APPLICATION NO.	FILING DATE	FIRST NAMED INVENTOR	ATTORNEY DOCKET NO.	CONFIRMATION NO.
09/982,801	10/22/2001	Johan Mercke	027557-072	8392

Office Action Summary

DETAILED ACTION

7. **Downs et al.** disclose a method and system for monitoring parameters of a rechargeable power supply. Fig. 1 of **Downs et al.** is reproduced below. From col. 2 of **Downs et al.**:

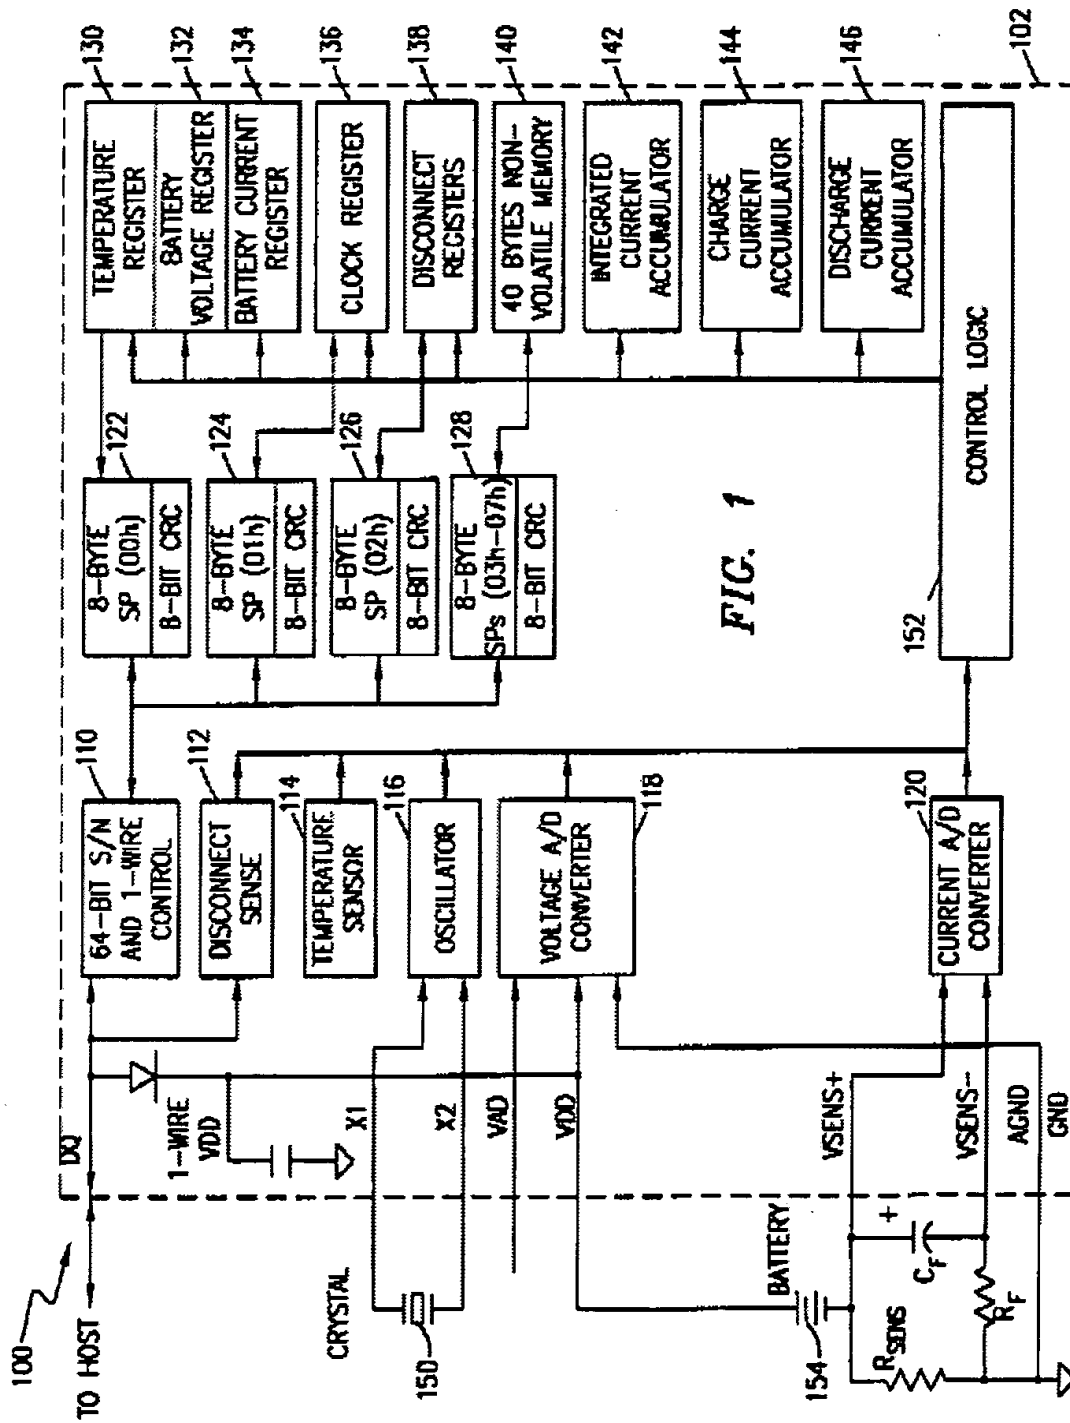
8. As per independent claims 1 and 24, and as can be seen from Fig. 1 reproduced above and its description by **Downs et al.**, we clearly see the claimed A/D, the logic unit, and the output register. The claimed processor is associated with the host of **Downs et al.**

9. As per dependent claims 38 and 46 which refer to a "digital signal stream", and the "logic unit adapted for updating the value of the or each parameter contained in the register as required in response to the digital signal stream", the Examiner interprets this as nothing more than overwriting a previously stored parameter with a newly acquired parameter in response to a clock signal or interrupt or other signal initiated by the control logic of **Downs et al.**
